**CITY OF WEST DES MOINES
PLAN AND ZONING COMMISSION COMMUNICATION**

Item: 5940 PUD, Southeast corner of University Avenue and 60th Street – Amend
5940 PUD to allow additional building height on PUD Parcel D – Iowa Clinic
West Lakes 1, LLC – ZC-004159-2018

Requested Action: Recommend approval of PUD Amendment

PUD SKETCH PLAN

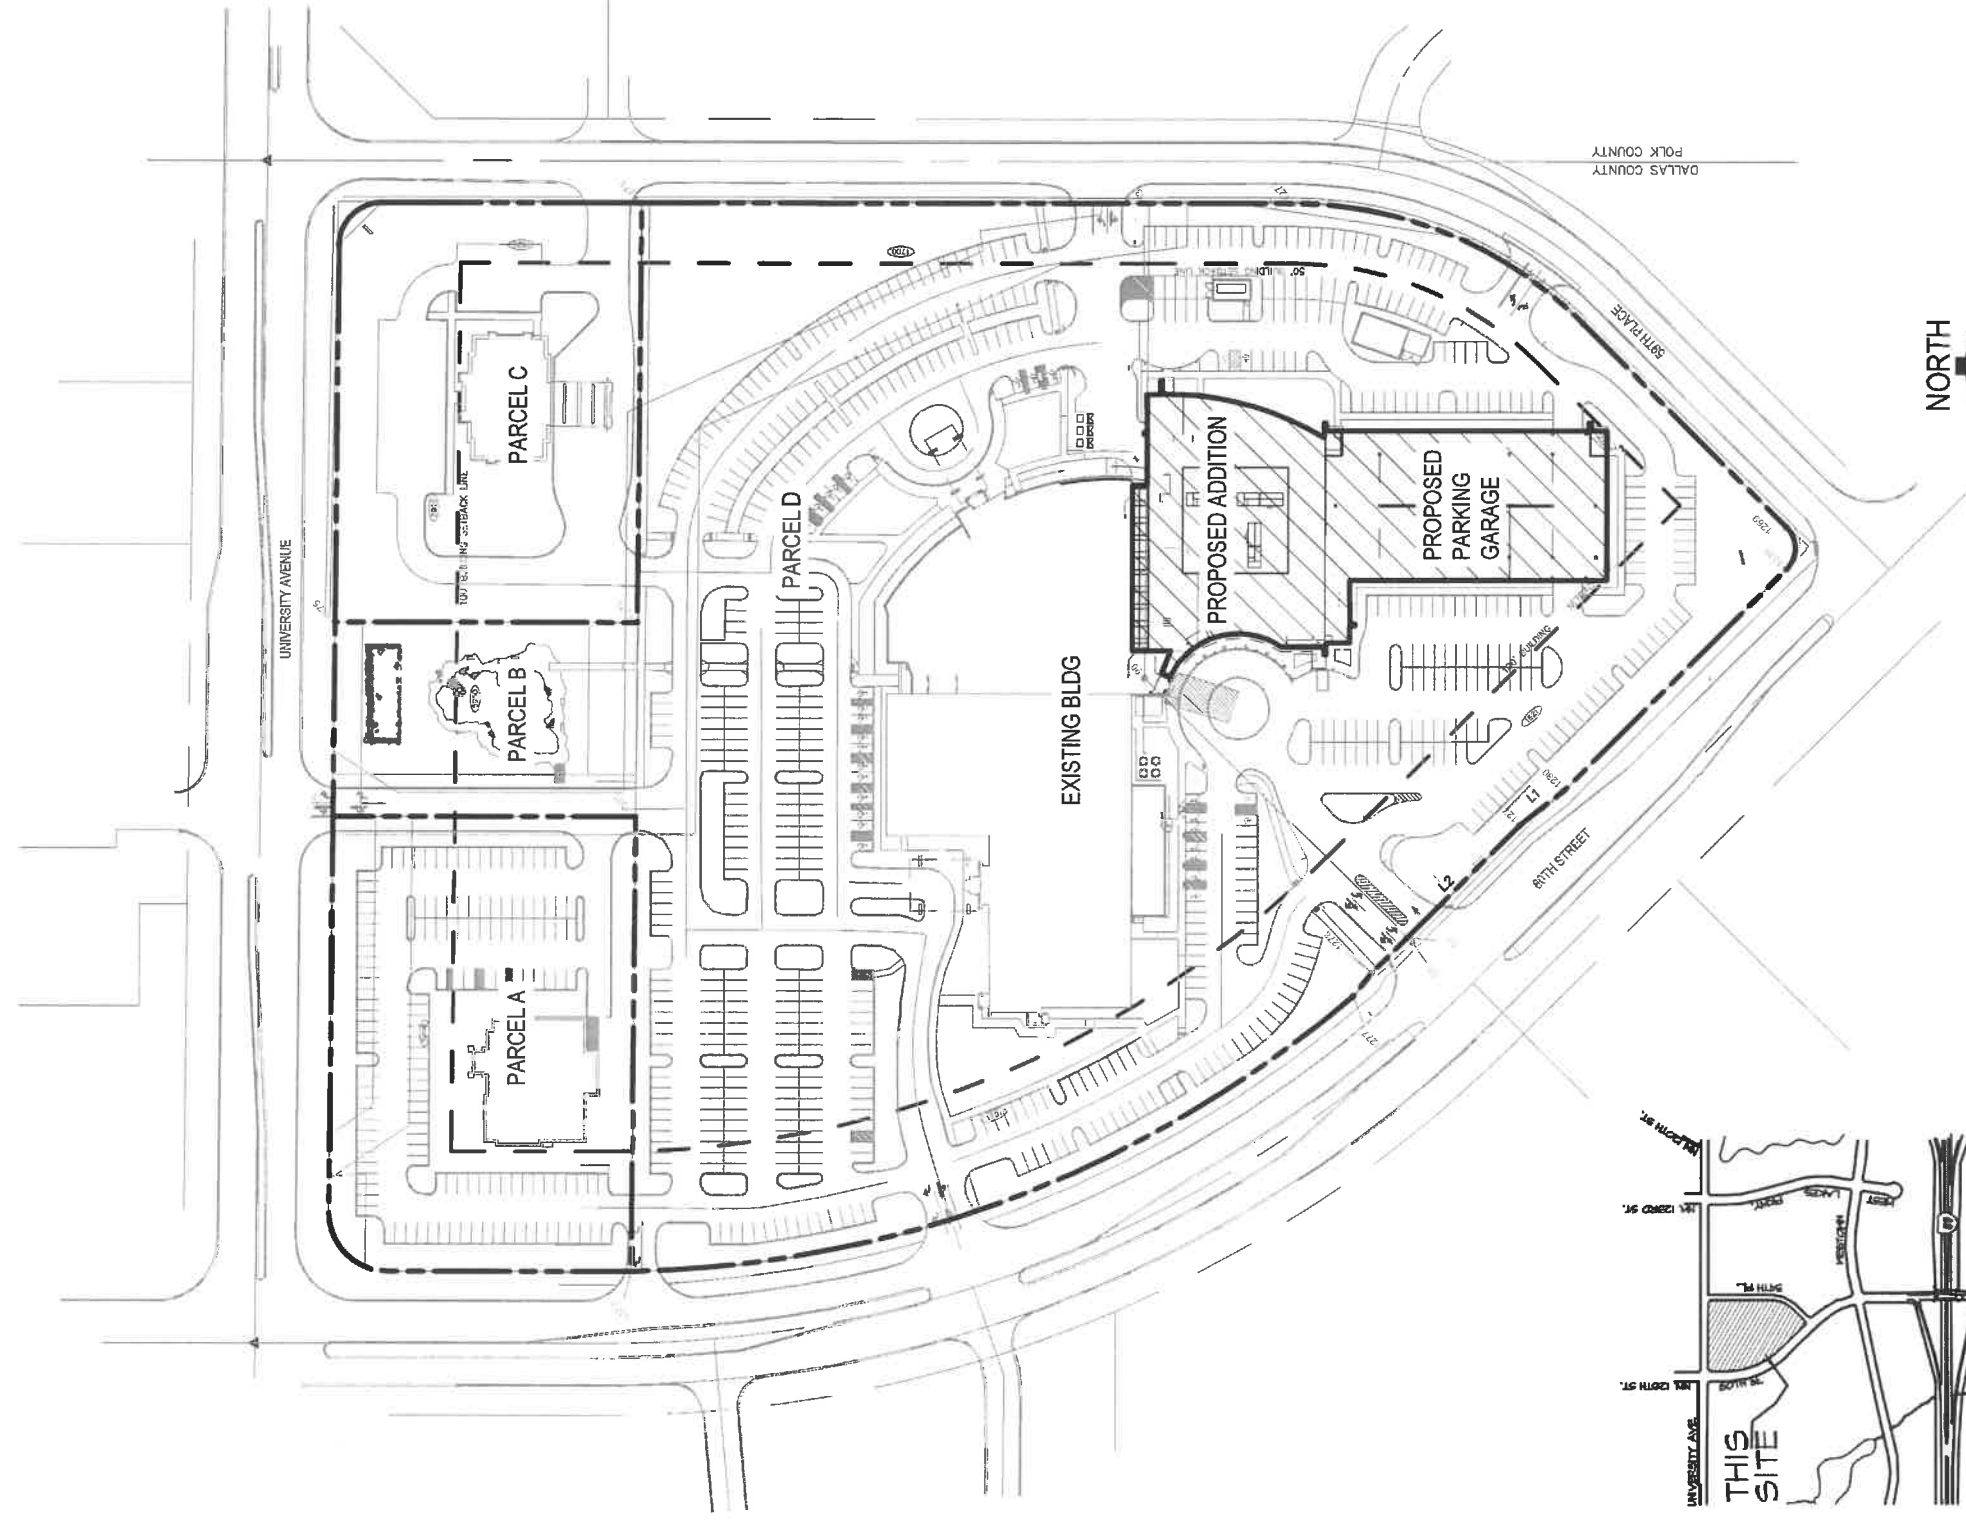
- **PUD Sketch Plan:** The current PUD Sketch Plan for the 5940 PUD is still labeled as Carmike PUD and indicates a 15-screen theater/family entertainment center on Parcel D where the Iowa Clinic is currently located. The applicant has provided an updated sketch plan for the PUD that shows the Iowa Clinic site plan on Parcel D and changes the title of the PUD to 5940 PUD on the sketch plan. The updated sketch plan will be incorporated into the PUD Ordinance as a part of this PUD amendment.

SECTION 1. AMENDMENT. Ordinances #1329, 1458, 1746, and 1880 pertaining to the **5940 Planned Unit Development**, complete ordinance; is hereby amended by replacing the PUD sketch plan with Exhibit A.
